Collected Action items for Task Force Meeting and SGS-8 Meeting
DRAFT

SGS-8 Meeting: All action items are due no later than March 31, 2010.

Source: FY 2001 Report by JARI

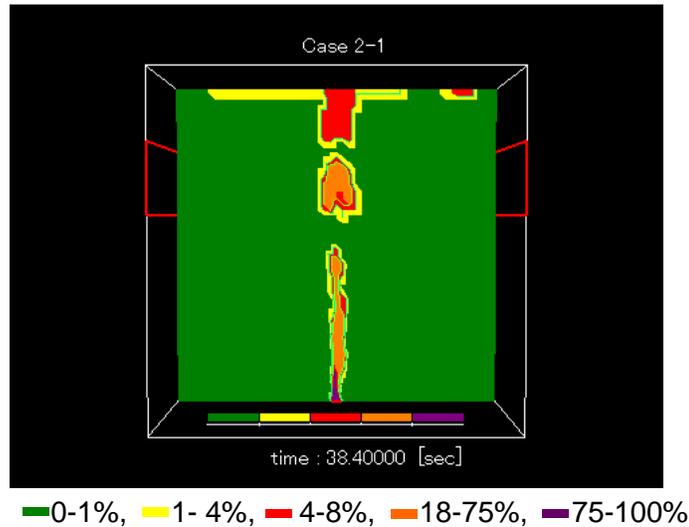
If, as a result of the study, it is shown that hydrogen that would cause hazards can enter the passenger compartment, we must discuss how to treat the hydrogen concentration that changes in terms of space and time.

The results of the above-mentioned JARI study, in which hydrogen was released into the passenger compartment from underneath its floor, and of a simulation study described below have clarified that distributions of the hydrogen concentration occur. From such standpoint, test procedures, test conditions, and pass/fail criteria that are appropriate for the actual crash testing must be developed based on the results of studies and investigations, including the following:

- * For distributed hydrogen concentration, at which locations should they be measured by using how many hydrogen-concentration measuring instruments?
- * How should the pass/fail status be determined for distributed hydrogen concentration?

* How should the appropriate time required for measuring hydrogen concentration be set?

The test procedures, test conditions and criteria should be developed based on the clarification of these questions.
